Addendum

New Glasgow Public Library & PARL Headquarters Revitalization

| 16 April 2024 | 23-053         | 04         |

**MSK-01**

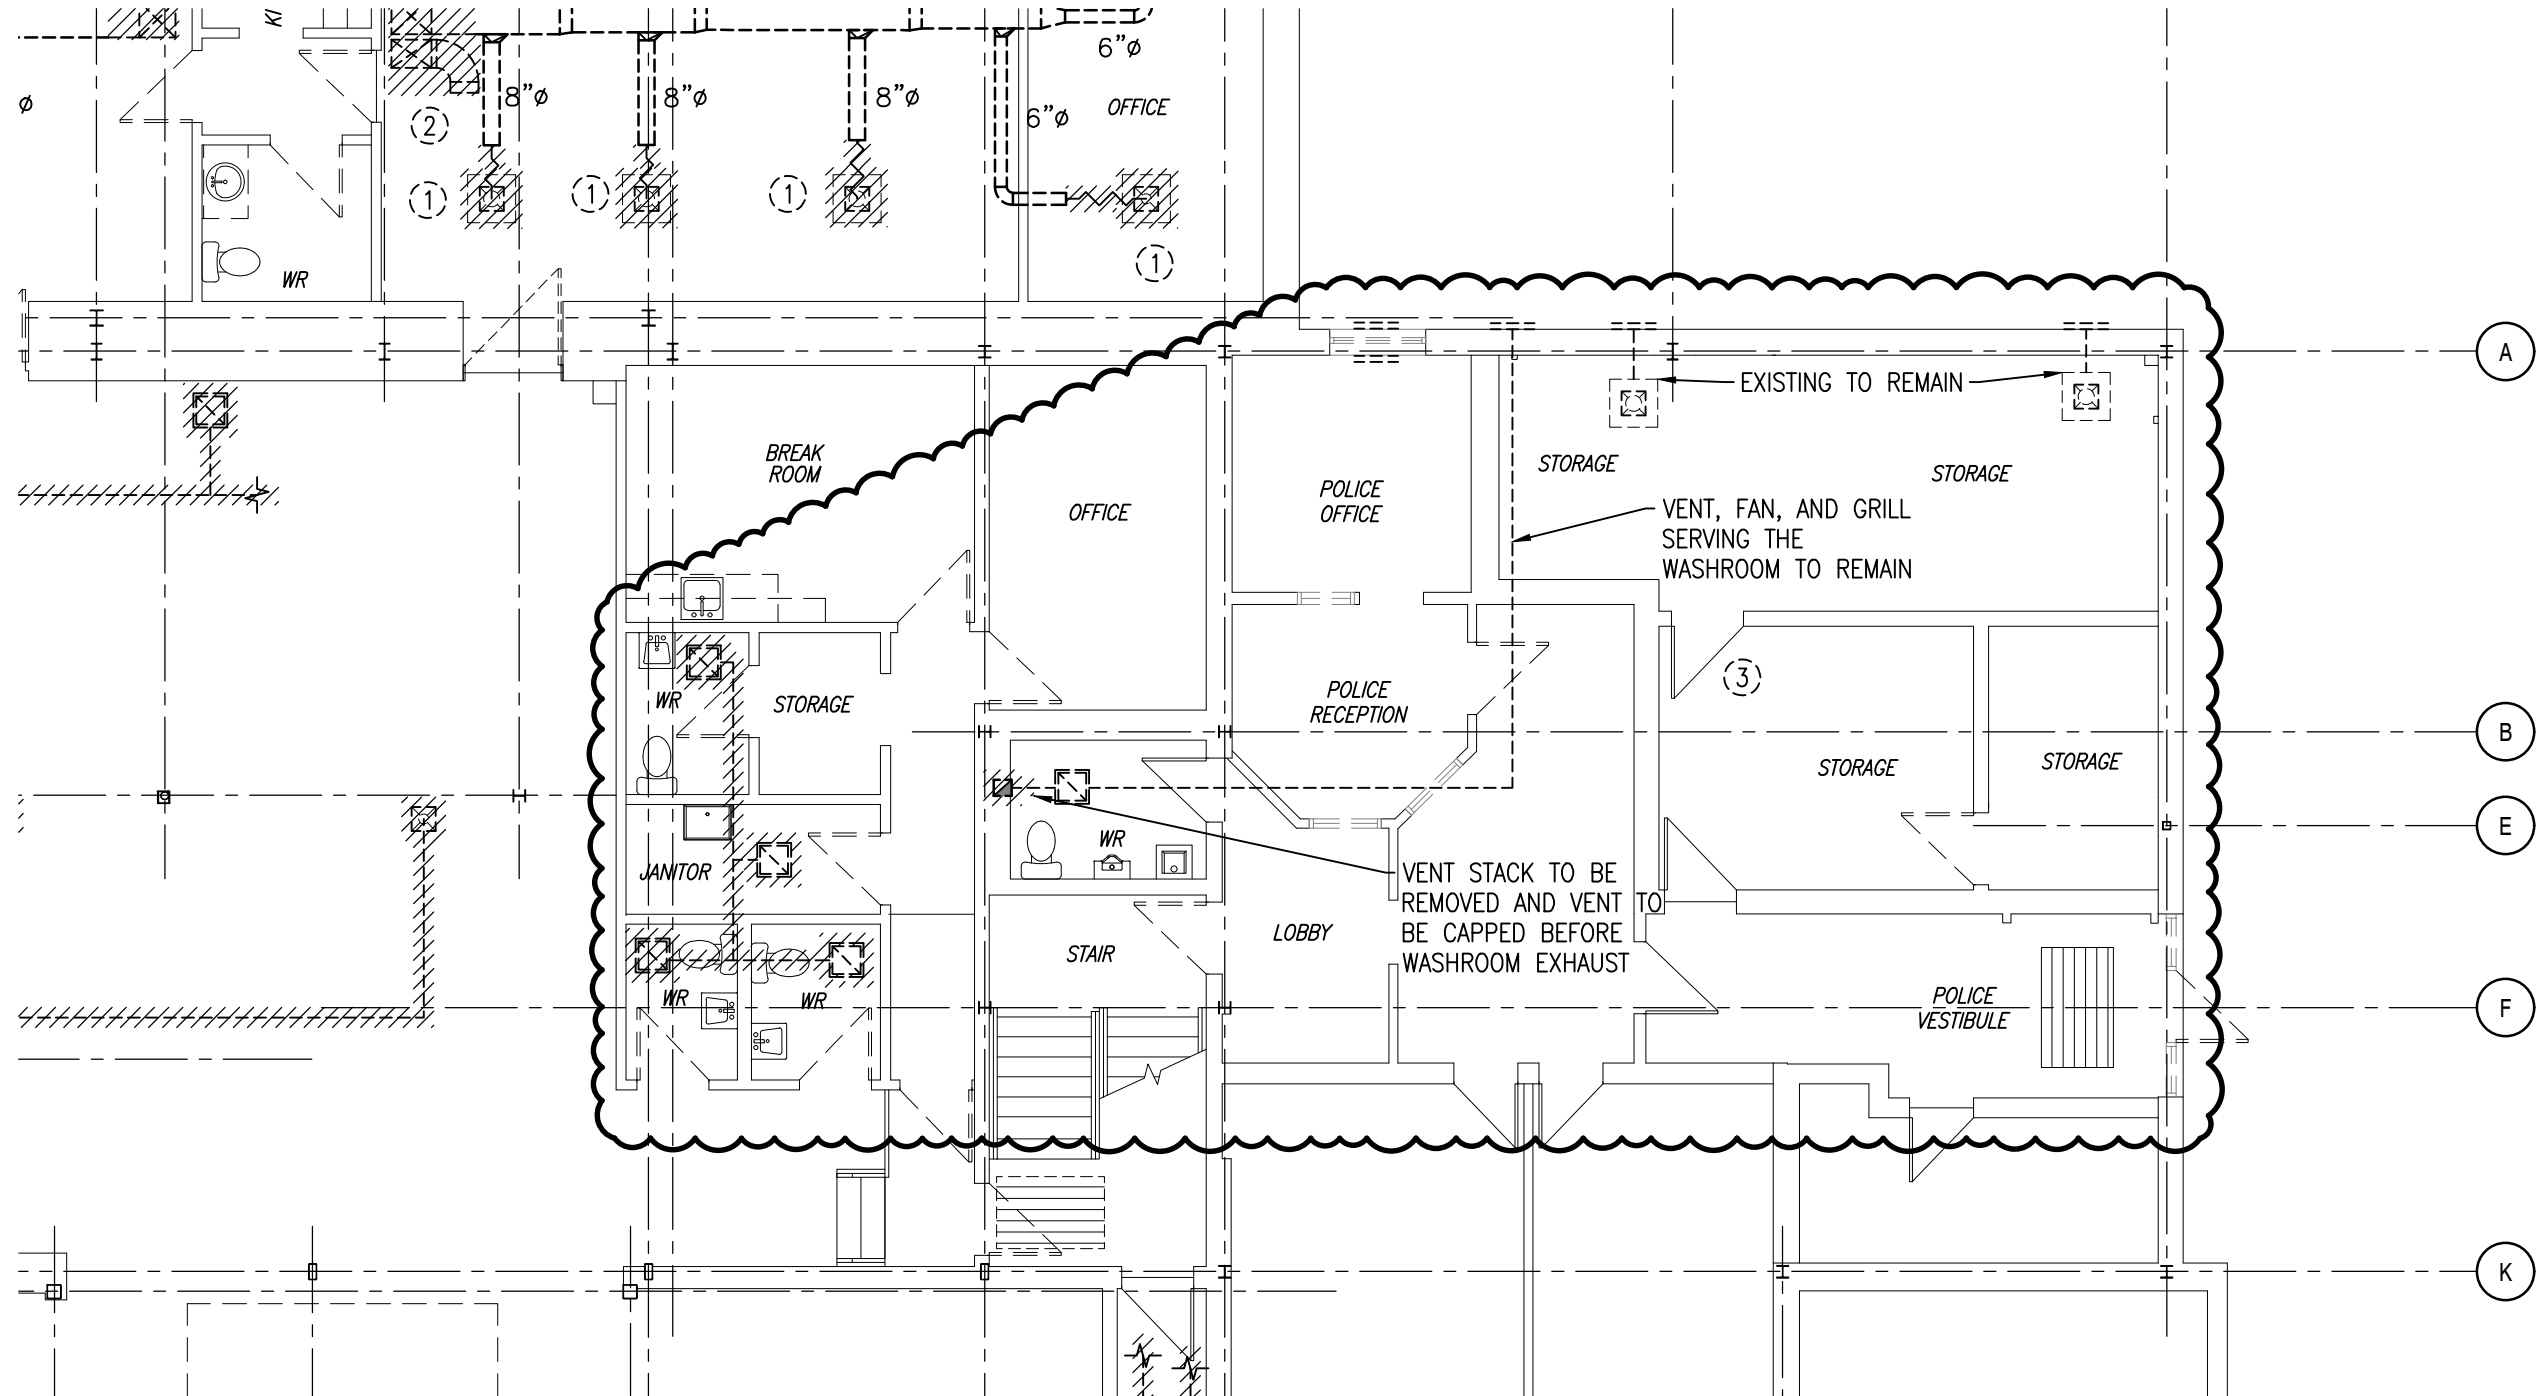
**2.8 Reference Drawing MV-101 Ventilation – Level 1 - Removal:** Revise with MSK01.

**MSK02**

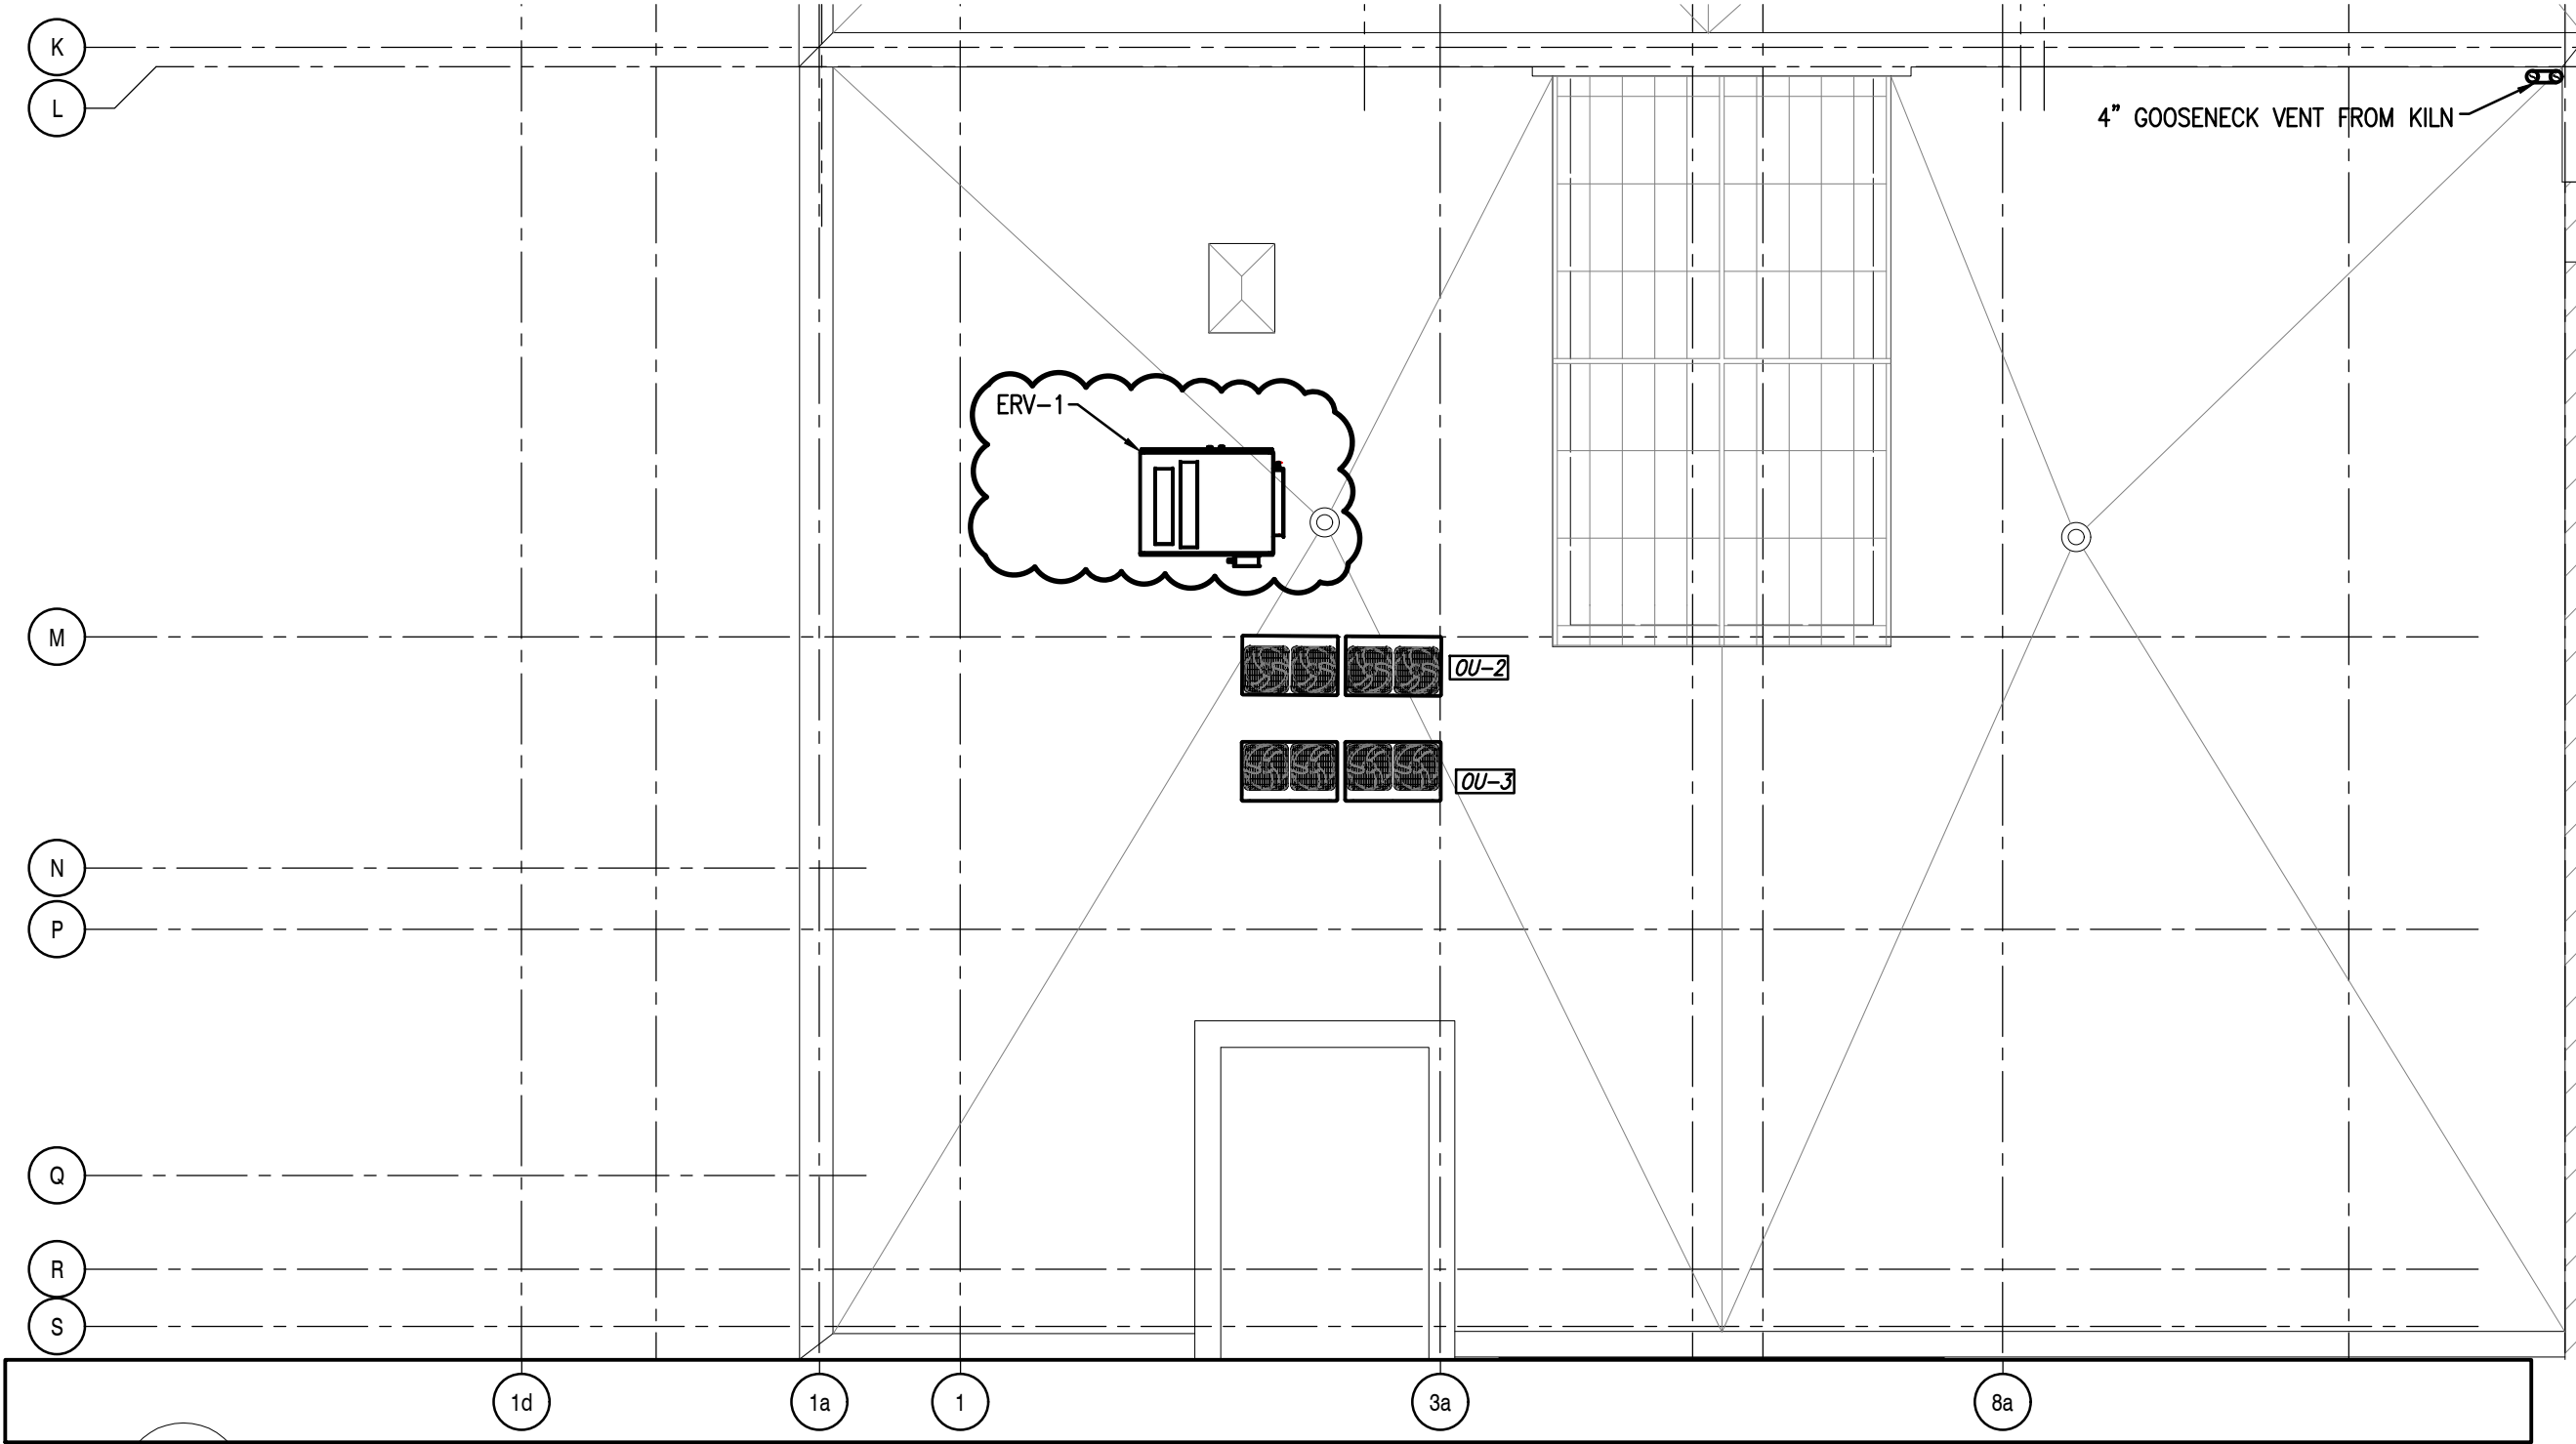
1. Revise with MSK02.
2. Revise with MSK03.
3. Add detail 2 as per MSK05.
